SUBJECT: POINT BEACH NUCLEAR PLANT, UNITS 1 AND 2 - STAFF ASSESSMENT OF INFORMATION PROVIDED PURSUANT TO TITLE 10 OF THE *CODE OF FEDERAL REGULATIONS* PART 50, SECTION 50.54(f), SEISMIC HAZARD REEVALUATIONS FOR RECOMMENDATION 2.1 OF THE NEAR-TERM TASK FORCE REVIEW OF INSIGHTS FROM THE FUKUSHIMA DAI-ICHI ACCIDENT (TAC NOS. MF3959 AND MF3960)

STAFF ASSESSMENT BY THE OFFICE OF NUCLEAR REACTOR REGULATION  
RELATED TO SEISMIC HAZARD AND SCREENING REPORT  
POINT BEACH NUCLEAR PLANT, UNITS 1 AND 2  
DOCKET NOS. 50-266 and 50-301

**Figure 3.3-1 Plot of Staff's and Licensee's Base Case Shear-Wave Velocity Profiles for the Point Beach Site**

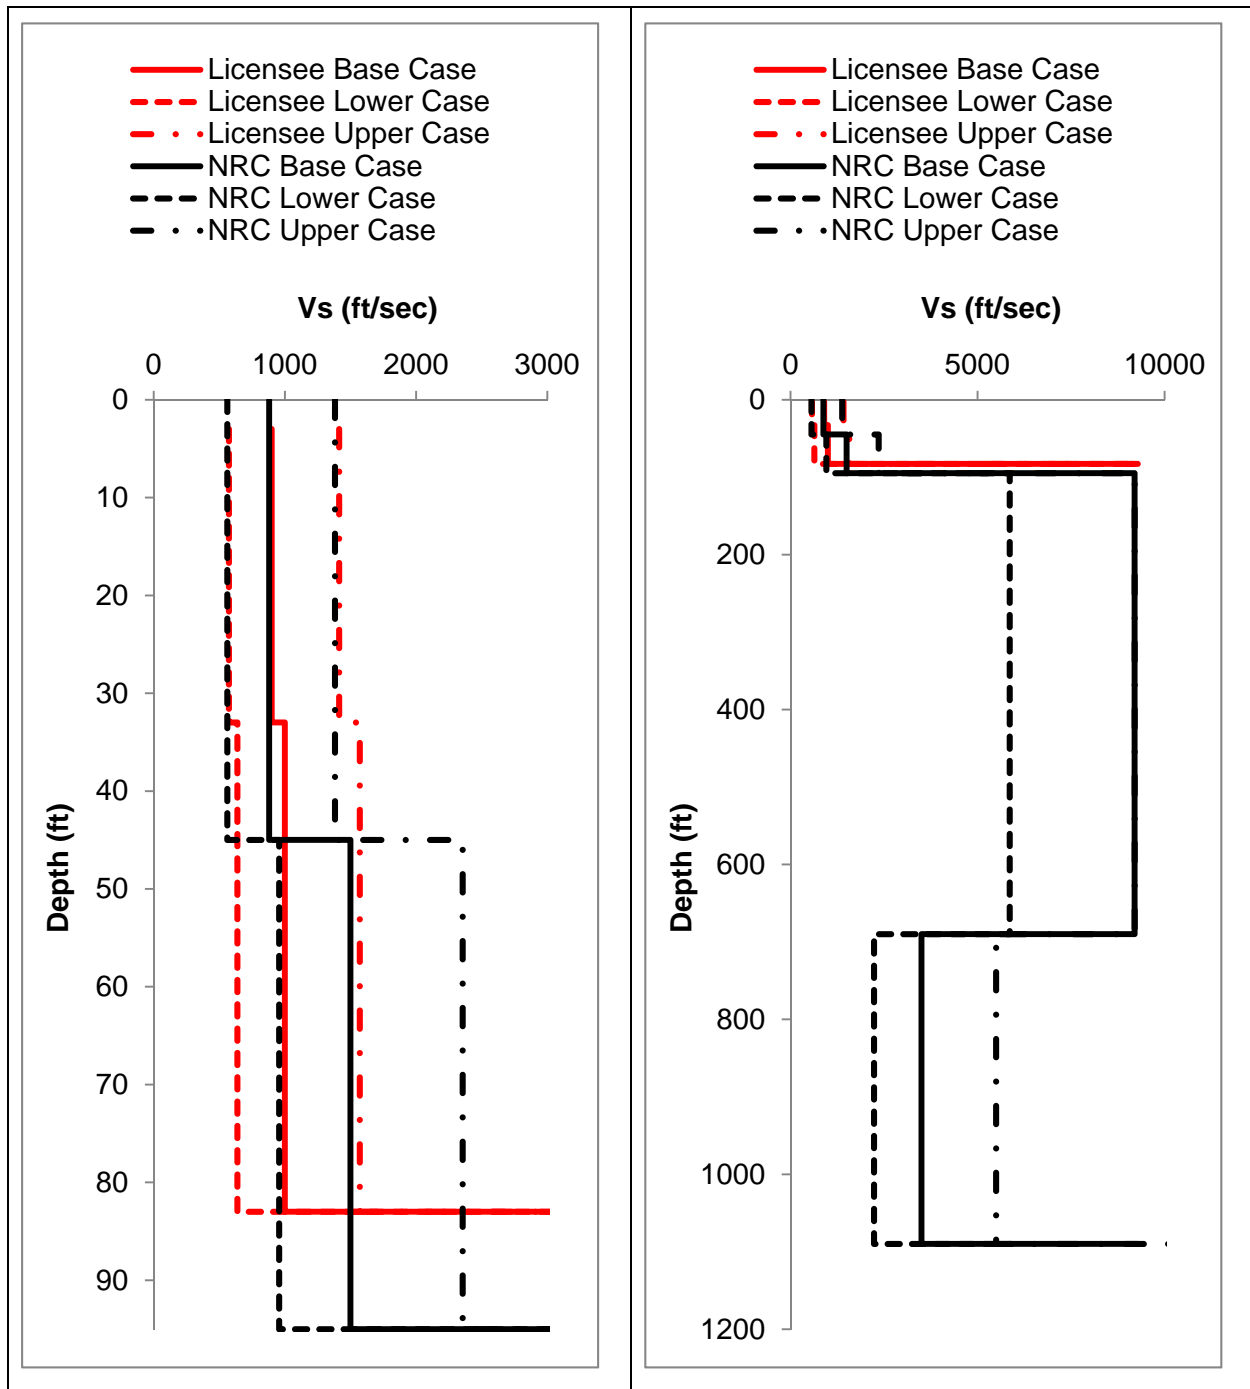
Using these measured shear-wave velocity estimates, along with guidance provided in the SPID, the licensee developed the best-estimate shear-wave velocity profile. The licensee also developed upper and lower base case profiles using a scale factor of 1.57, which implies a natural log standard deviation of 0.35, following guidance in the SPID. This approach to developing base case profiles resulted in three profiles, which are shown below in Figure 3.3-1 of this assessment.

To confirm the licensee's site response analysis, the NRC staff performed site response calculations for the Point Beach site. The NRC staff independently developed three base case shear-wave velocity profiles from information provided in UFSAR. The NRC staff developed three separate profiles in order to capture the epistemic uncertainty in the shear wave velocity of the subsurface layers. The NRC staff's base case shear-wave velocity profiles are shown along with the licensee's base case profiles in Figure 3.3-1 of this assessment. The NRC staff's shear wave velocity profiles agree well with those submitted by the licensee over the upper 80 ft (24 m) where the licensee's profile encounters bedrock. The NRC staff's profile continues to a depth of 1100 ft (335 m) in order to account for the lower velocity Maquoketa formation that the general geology suggests lies beneath the higher velocity Niagara formation. The NRC staff considered shear wave velocity information for the Maquoketa formation from other nuclear

power plant sites and concluded that the Maquoketa formation was a softer rock than what is considered by the SPID to be hard reference or base rock and therefore the NRC staff's profile extends to a depth of 1100 ft (335 m), which is the bottom of the Maquoketa Formation.

Using the guidance provided in the SPID for the determination of site kappa resulted in values of 0.010 sec, 0.015 sec and 0.007 sec for the base, lower and upper base case profiles, respectively. These values are slightly higher than the licensee's values due to the additional depth to base rock in the NRC staff's profiles. In addition, to account for the aleatory variability in material properties across the plant site, the NRC staff randomized its base case shear-wave velocity profiles following the SPID guidance provided in Appendix B of the SPID.

**Figure 3.3- 1 Plot Comparing the NRC staff's and the Licensee's Median Amplification Functions and Uncertainties for the Point Beach site.**

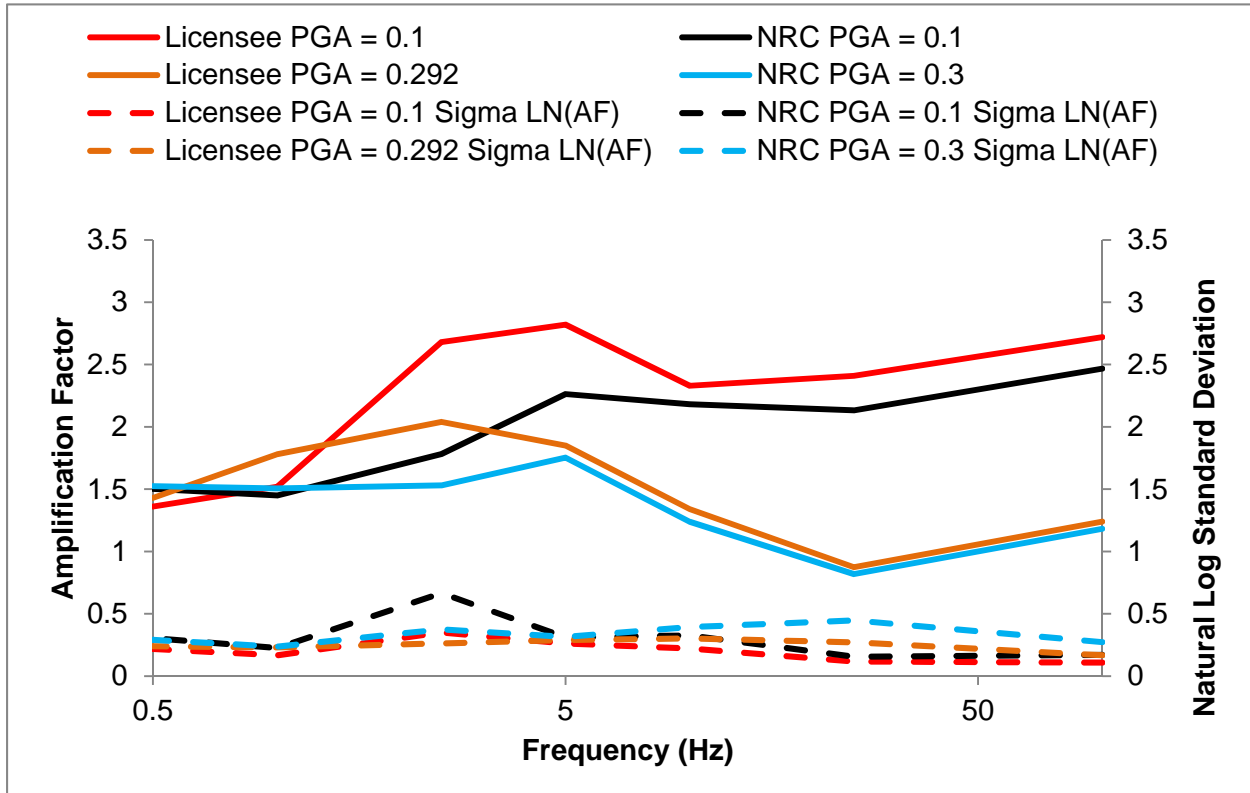
In order to calculate control point hazard curves for the Point Beach site, the licensee and NRC staff developed median amplification functions for the site for several different loading levels. The median site amplification and associated uncertainty for two separate loading levels are shown in Figure 3.3-2 of this assessment. It can be seen that both the NRC staff's and licensee's site amplifications are similar in shape with small differences at peak amplification, which is due to the more shallow subsurface profile used by the licensee. The licensee's and staff's control point hazard curves resulting from the convolution of the site amplification with the PSHA rock hazard are shown in Figure 3.3-3 of this assessment. As shown in Figure 3.3-3, the licensee's and staff's control point hazard curves for the Point Beach site are very similar.

**Figure 3.4-1 Comparison of the NRC staff's GMRS with Licensee's GMRS and the SSE for the Point Beach site**

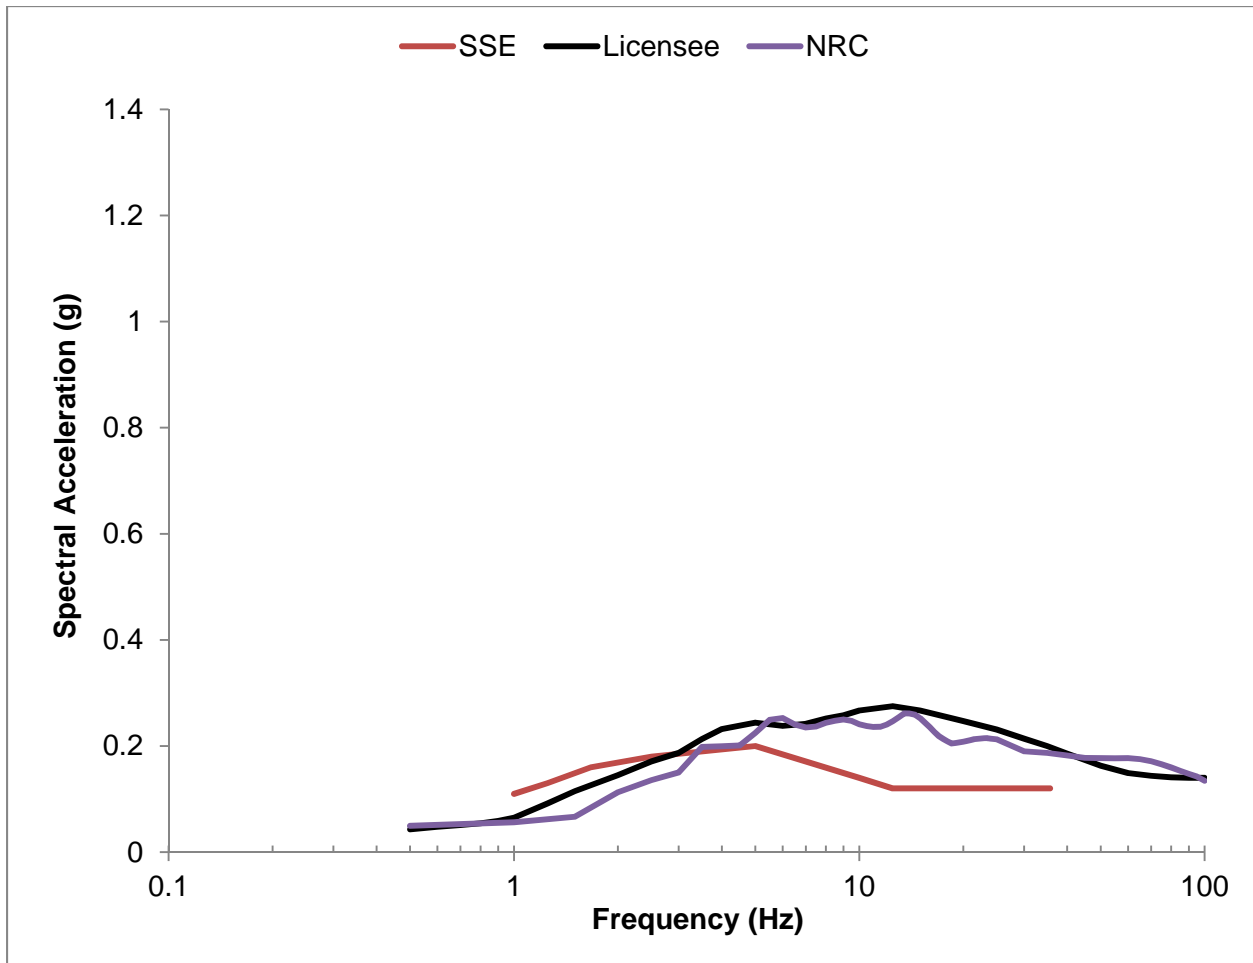
The NRC staff independently calculated the  $10^{-4}$  and  $10^{-5}$  UHRs using the results of its confirmatory PSHA and site response analysis, as described in Sections 3.2 and 3.3 of this staff assessment, respectively. Figure 3.4-1 of this assessment shows a comparison of the GMRS determined by the licensee to that determined by the NRC staff. As shown in Figure 3.4-1, the licensee's GMRS shape is generally similar to that calculated by the NRC staff, although the

licensee's GMRS is slightly higher than the NRC staff's. These differences in GMRS are the result of differences in the site response analyses performed by the licensee and staff as discussed in Section 3.3 above. The NRC staff concludes that these differences are acceptable for this application because the licensee followed the guidance provided in the SPID with respect to both the PSHA and site response analysis for the Point Beach site.
